TO: Chairman Robert Patrick, Dekalb County
ATTN TO: Larry Washington, Planning Administrator, Dekalb County
FROM: Mike Alexander, Director, ARC Center for Livable Communities
RE: Development of Regional Impact (DRI) Review

Name of Proposal: North Dekalb Mall Redevelopment DRI 3582

Description: A DRI Review of a proposal to redevelop the North Dekalb Mall as a mixed-use residential, office and retail center on its existing 74.3 acre site at 2050 Lawrenceville Highway in Dekalb County. The project will include a total of 300,000 SF of new or repurposed retail space, 100 townhomes, 1,700 multi-family units, 150 hotel rooms, and 200,000 SF of office space. A conservation area with walking trails will be dedicated next to the existing nature preserve west of the site. The project will include an extensive sidewalk network connecting to the surrounding areas as well as a segment of a multi-use regional trail. Vehicular access will be provided by five existing full movement driveways along North Druid Hills Road and Lawrenceville Highway. The DRI trigger is a request to rezone the property from C-1 to MU-5.

Drawing name: K:\ALP_PRJ\018381014_North Dekalb Mall\CAO\Plansheets\C1-50 - DRI SITE PLAN.dwg C1-50 REZONING SITE PLAN Mar 17, 2022 4:20pm by: Taylor Jones

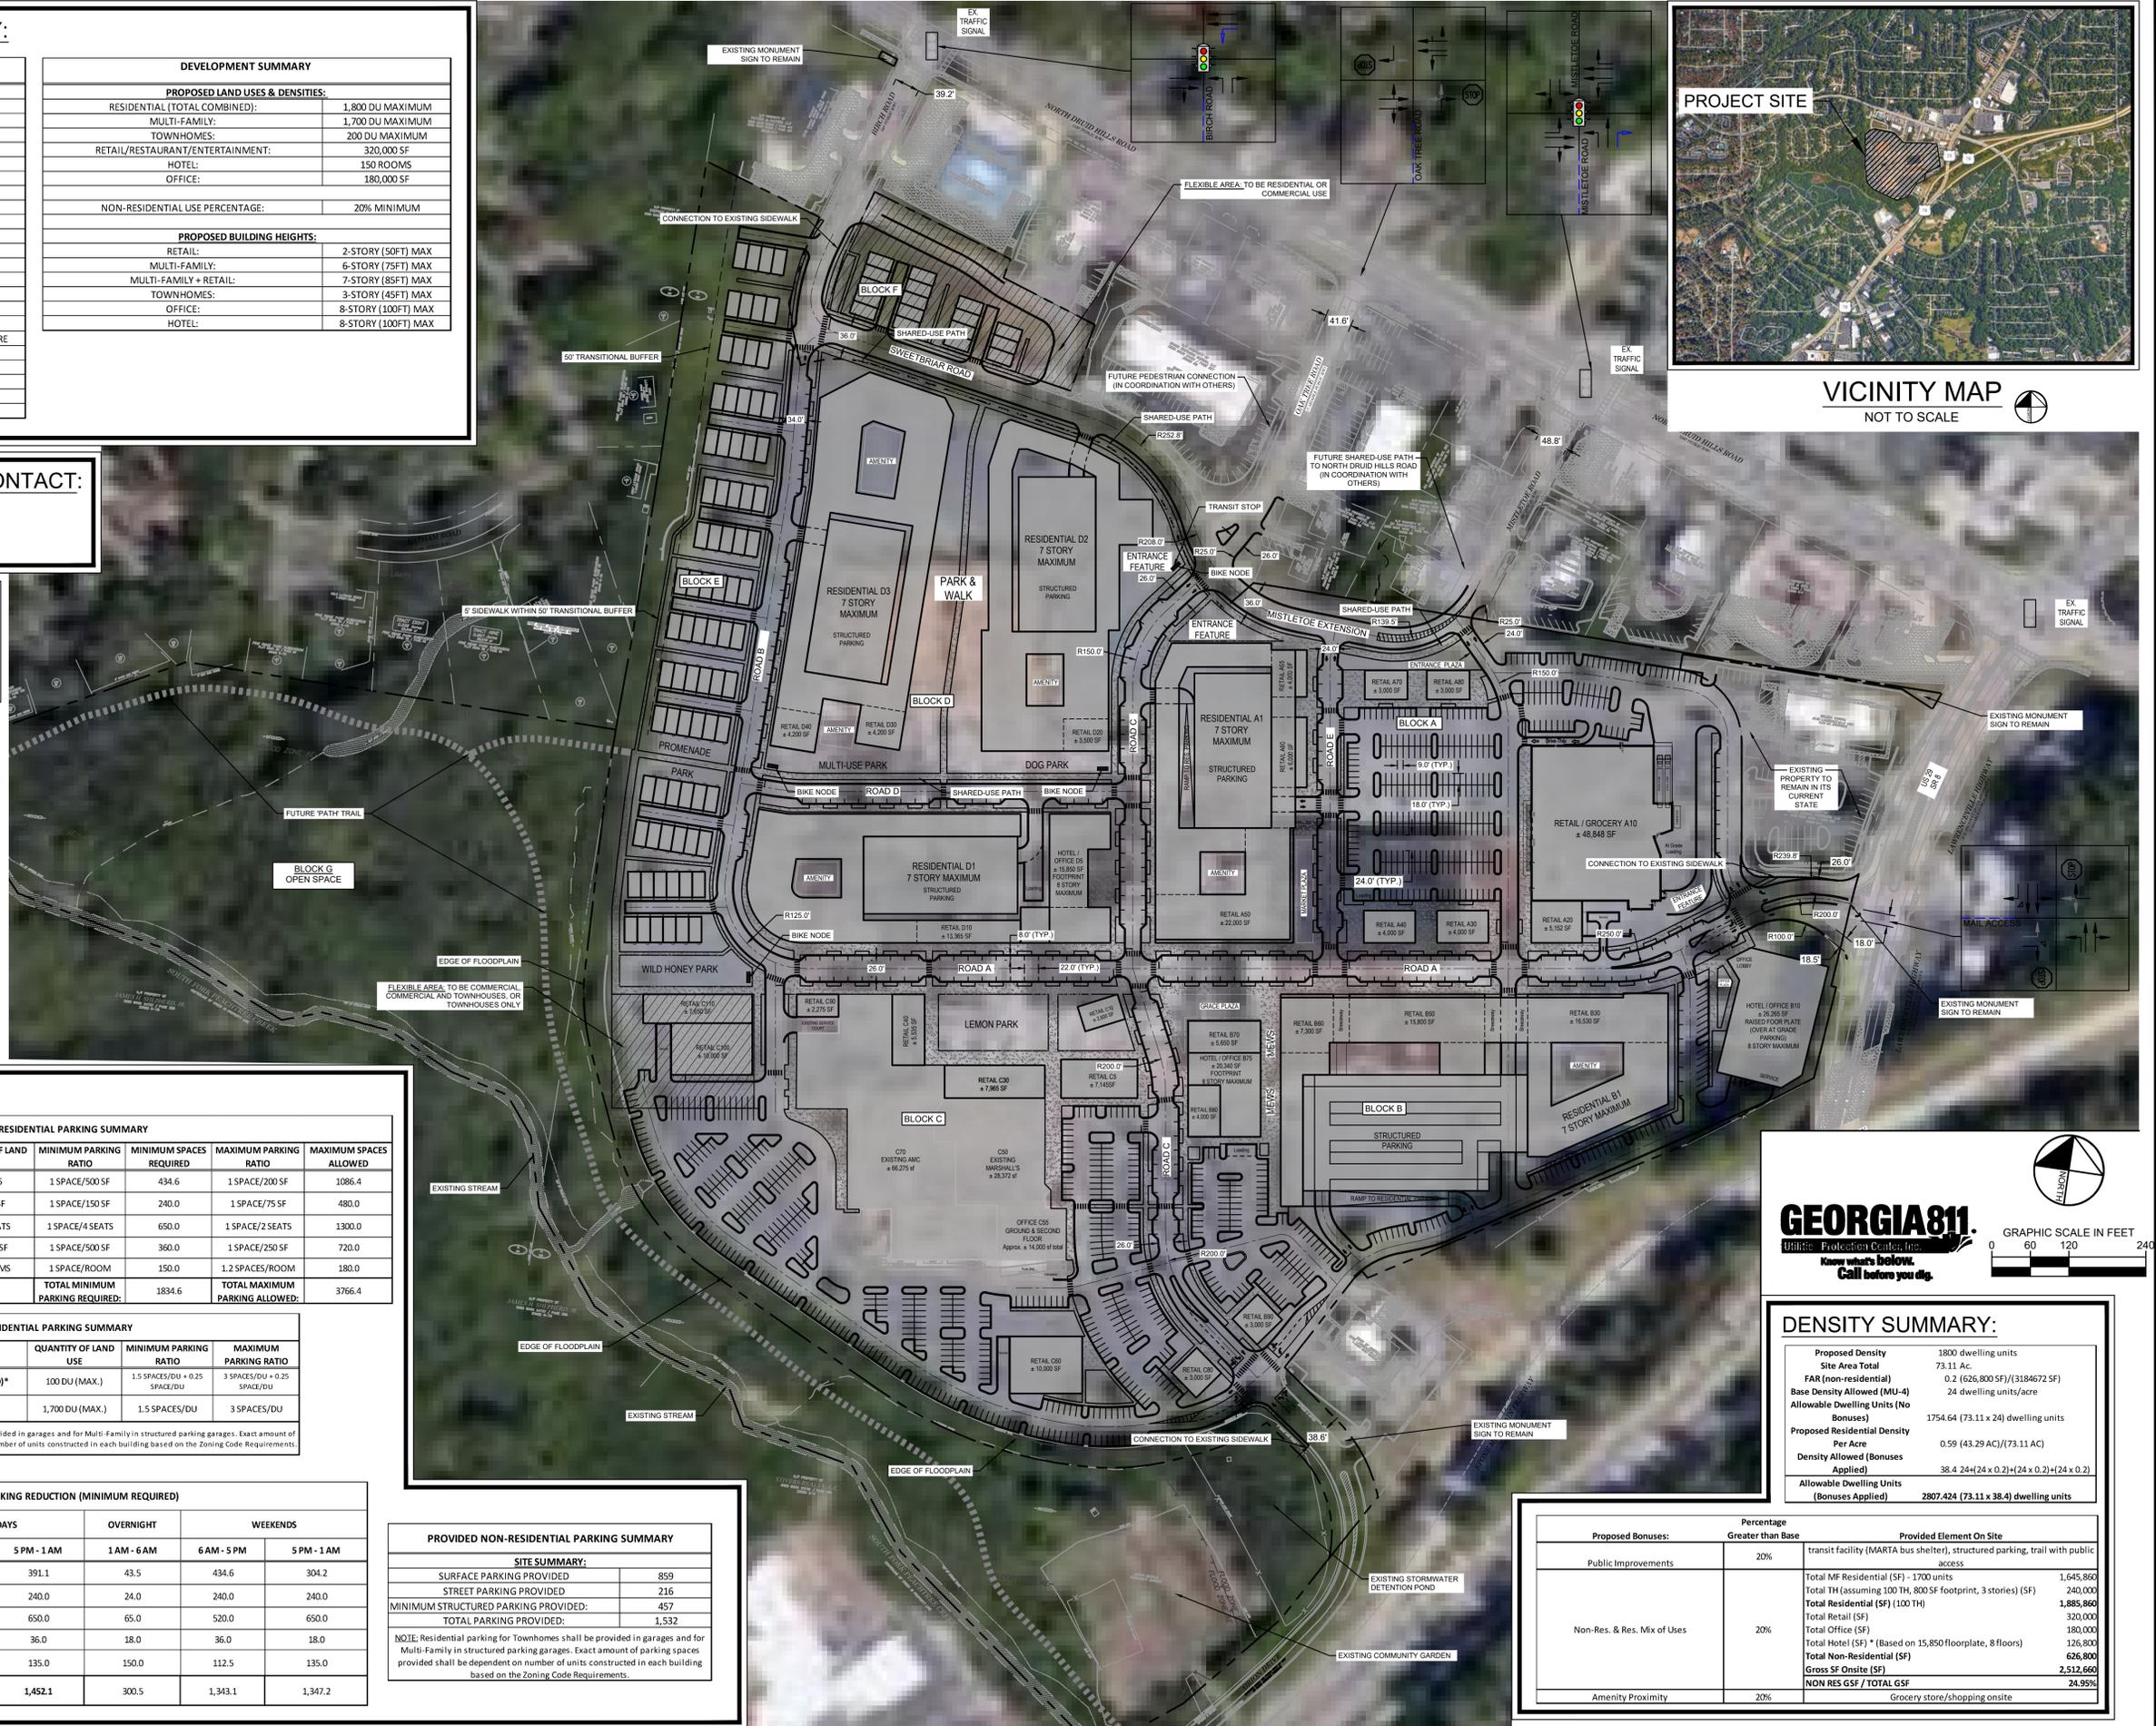
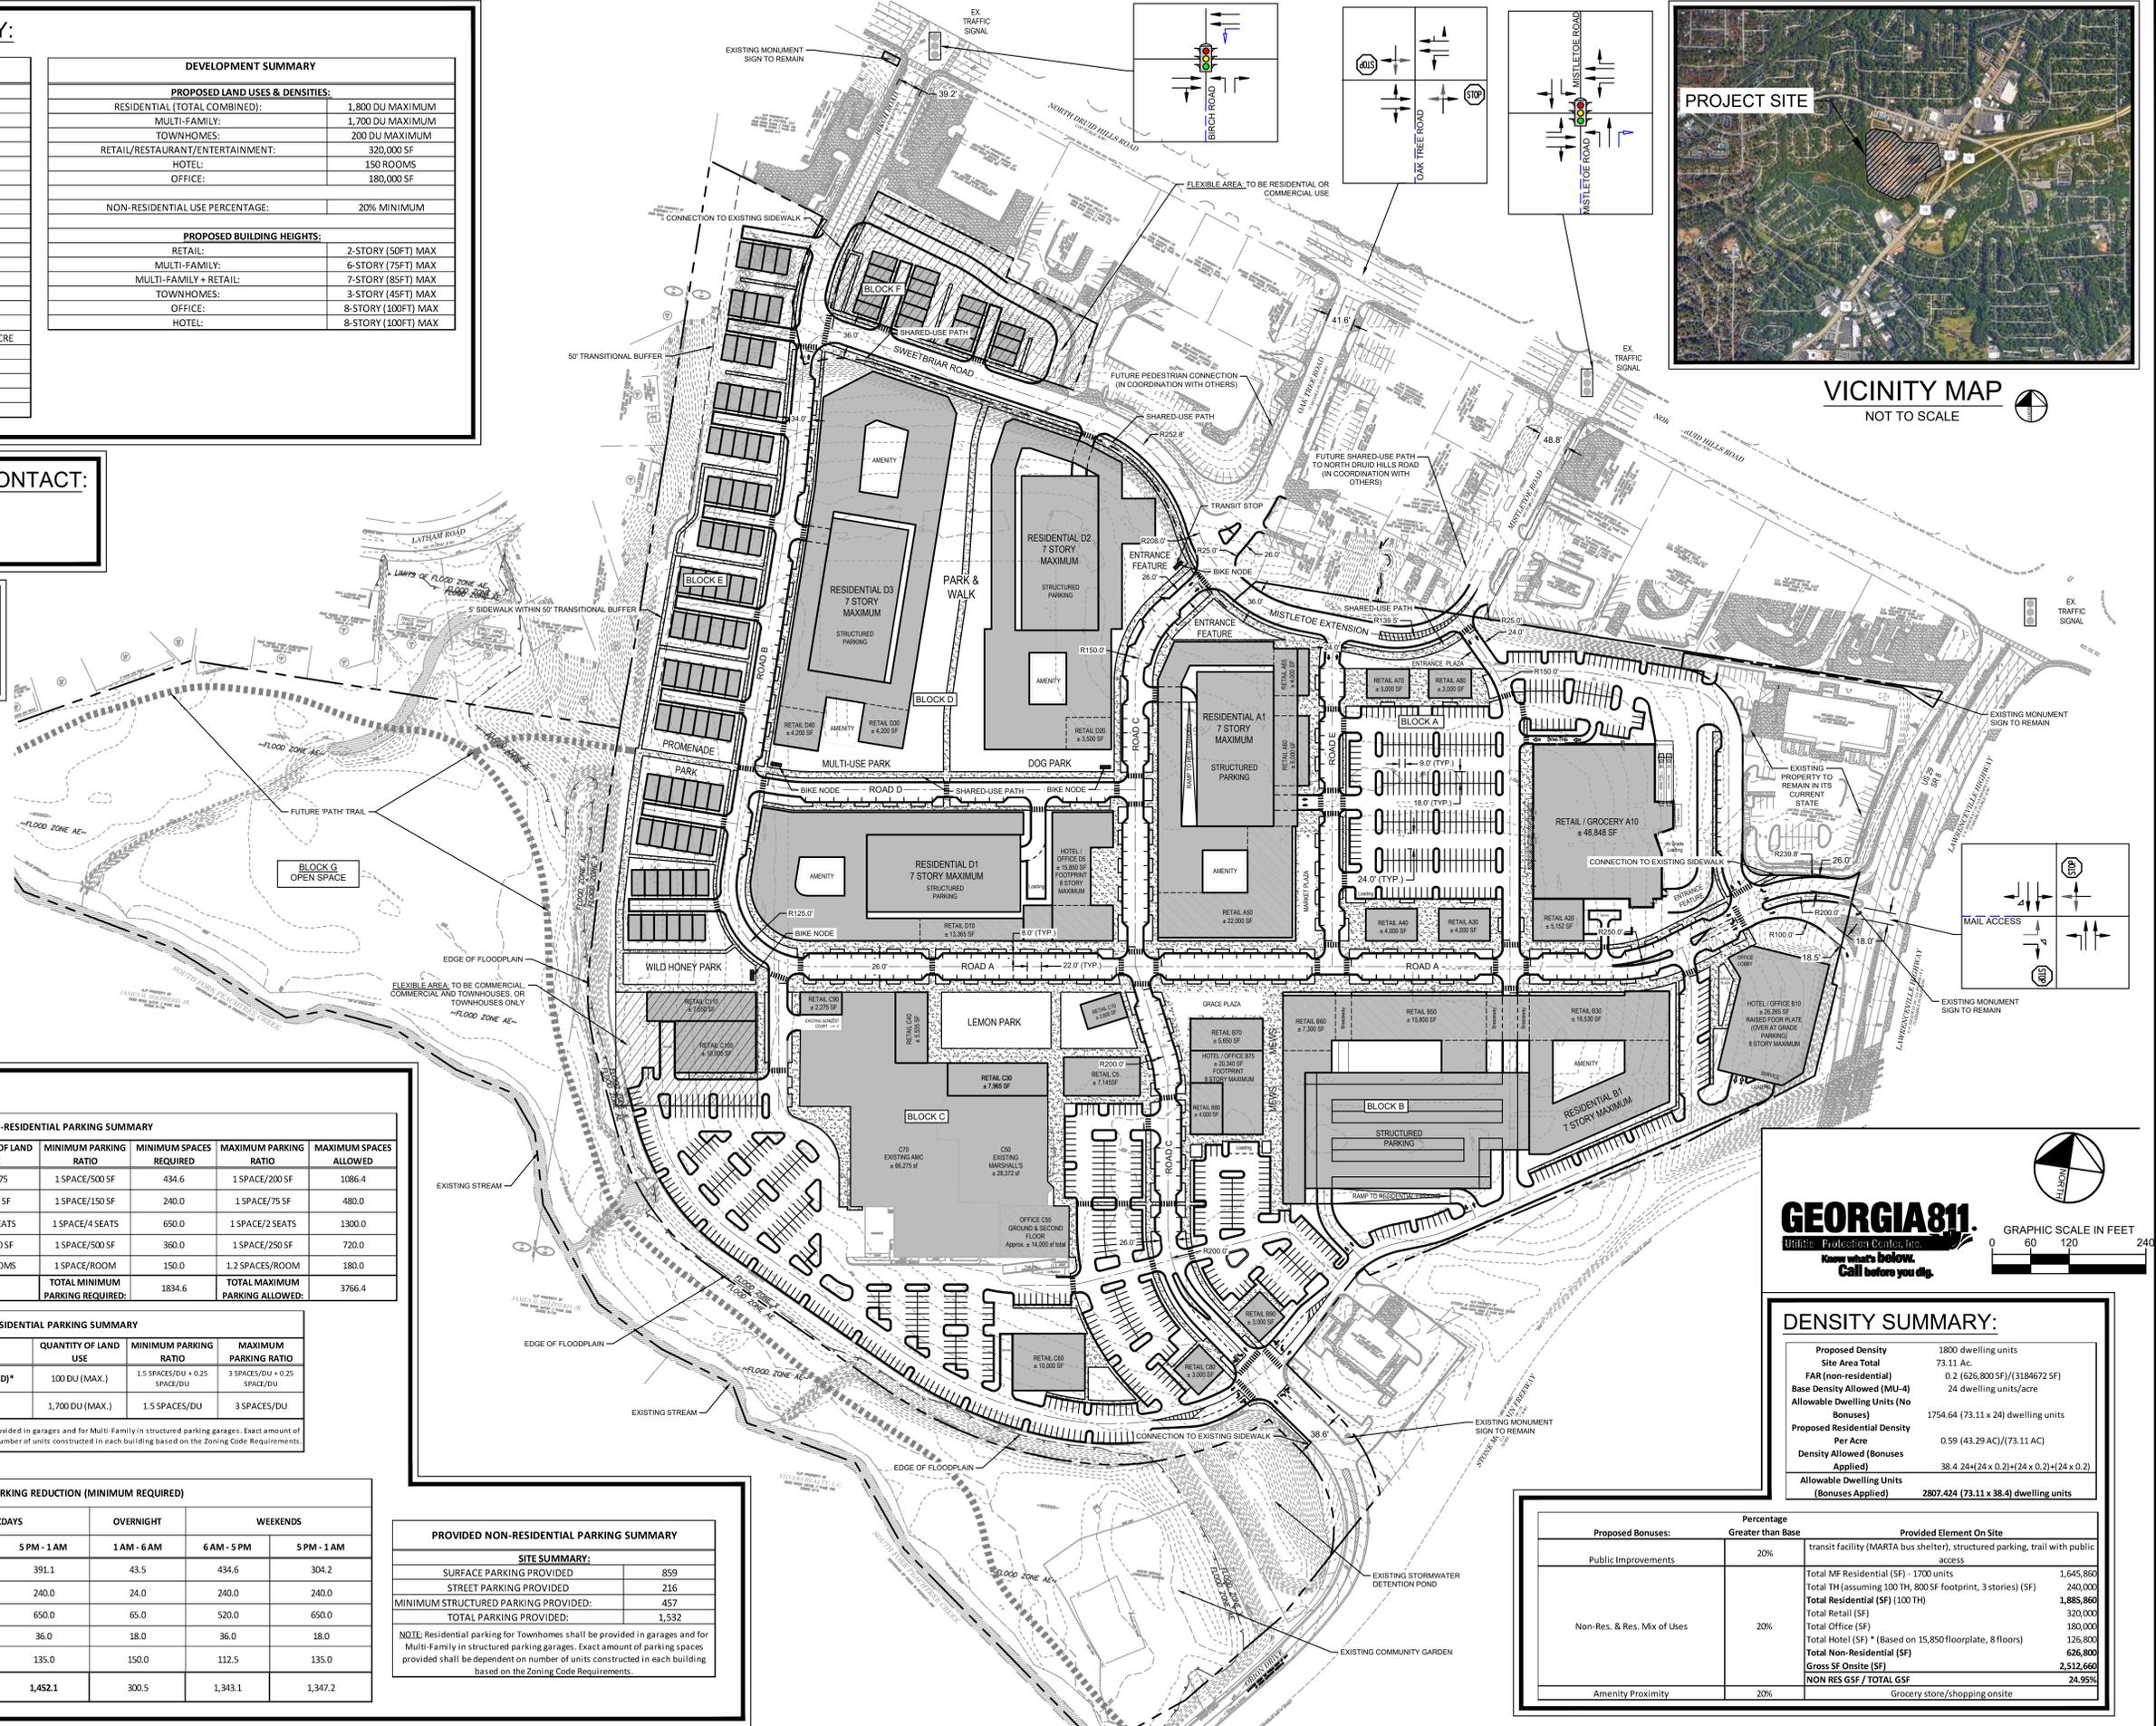
Additional bicycle parking spaces would strengthen the project's multi-modal transportation approach. Care should be taken to ensure that the constructed development provides an interconnected, functional, clearly marked and comfortable pedestrian experience on all driveways, paths, entrances, and parking areas. To the maximum extent possible, new driveways and intersection corners where pedestrians will cross should be constructed with minimal curb radii to reduce speeds of turning vehicles and decrease crossing distances for pedestrians.

The site plan and the USGS coverage for the project area show the South Fork of Peachtree Creek forming the southwestern and western boundaries of the project property. The site plan also shows an unnamed tributary to the South Fork of Peachtree in the western end of the property. Neither the County 75-foot stream buffer or 25-foot State Sediment and Erosion Control buffer are shown along the streams. However, both are entirely within the conservation area portion of the project, which extends beyond the width of the buffers. The only proposed activity shown in the conservation area is a proposed future trail paralleling the South Fork of Peachtree Creek. Given that paths are allowed in the buffer under the DeKalb ordinance, a variance may not be needed outside the 25-foot State buffer. Any unmapped streams on the property may also be subject to the City buffer ordinance. Any unmapped State waters identified on the property may also be subject to the State 25-foot Sediment and Erosion Control buffer.

The site plan and the USGS coverage for the project area show the South Fork of Peachtree Creek forming the southwestern and western boundaries of the project property. The site plan also shows an unnamed tributary to the South Fork of Peachtree in the western end of the property. Neither the County 75-foot stream buffer or 25-foot State Sediment and Erosion Control buffer are shown along the streams. However, both are entirely within the conservation area portion of the project, which extends beyond the width of the buffers. The only proposed activity shown in the conservation area is a proposed future trail paralleling the South Fork of Peachtree Creek. Given that paths are allowed in the buffer under the DeKalb ordinance, a variance may not be needed outside the 25-foot State buffer. Any unmapped streams on the property may also be subject to the City buffer ordinance. Any unmapped State waters identified on the property may also be subject to the State 25-foot Sediment and Erosion Control buffer.
